## **OVERLOOK PLACE SUBDIVISION**

APPLICATION NUMBER 26 DATE July 19, 2007

REQUEST Subdivision

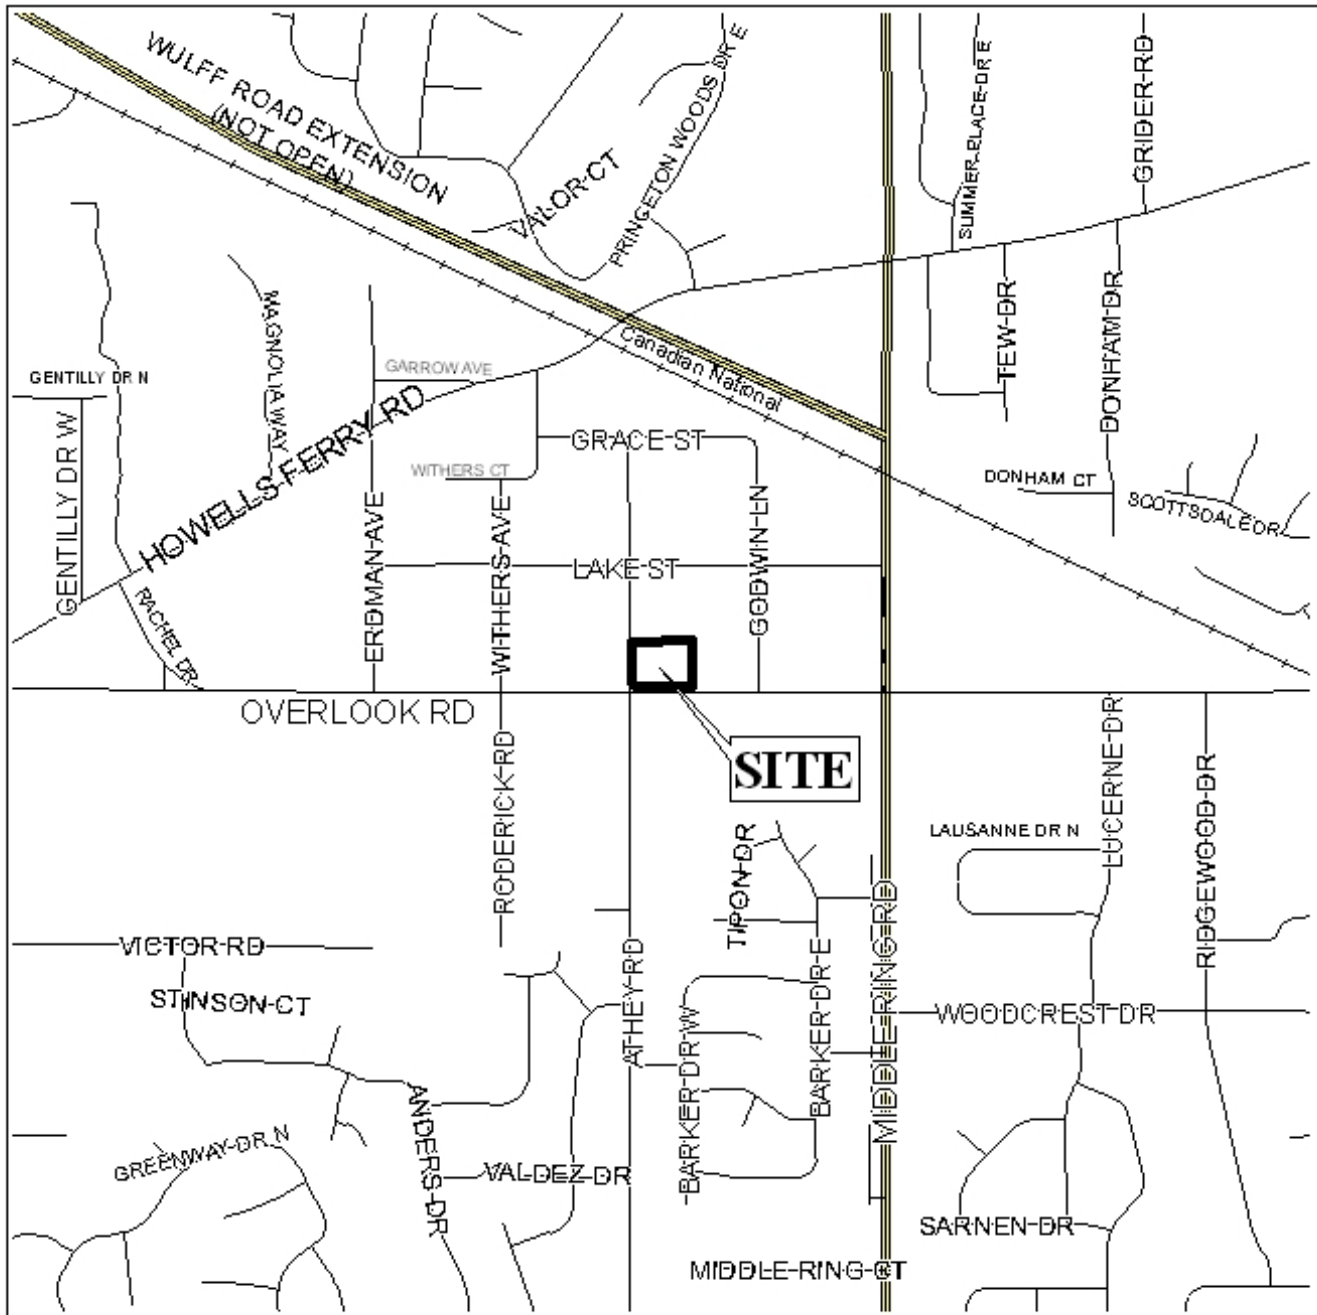
The site fronts Garwood Avenue, a minor street with adequate right-of-way to the West, and Overlook Road, a collector street with adequate right-of-way to the South. The proposed Lot 1 has 217.92-feet of frontage on Garwood Avenue and 124.06-feet of frontage on Overlook Road. Both the proposed Lots 2 and 3 have 80-feet of right-of-way frontage on Overlook Road. Currently the site does not include a curb radius at the intersection of Overlook Road and Garwood Avenue as required by Section V.B16 of the Subdivision Regulations. The required dedication is illustrated but not labeled on the plat. The dedication should be labeled as such.

Given that the proposed Lot 1 is already developed, it should be limited to the existing curb cuts. Do to their amount of street frontage and the fact that Overlook Road functions as a collector street, the proposed Lots 2 and 3 should be limited to one curb cut each, with the sizes, location and design to be approved by Traffic Engineering and conform to AASHTO standards.

The plat does not illustrate the minimum building setbacks, and thus the plat should be revised to reflect the 25-foot minimum building setback line on all street frontages in accordance with Section V.D.9 of the Subdivision Regulations.

- 1) dedication of a radius at the intersection in compliance with Section V.B.16 of the Subdivision Regulations;
- 2) illustration of the 25-foot minimum building setback on all street frontages; and
- 3) placement of a not on the final plat stating that Lot 1 is limited to the existing curb cuts and that Lots 2 and 3 are limited to one curb cut each, with the sizes, location and design to be approved by Traffic Engineering and conform to AASHTO standards.
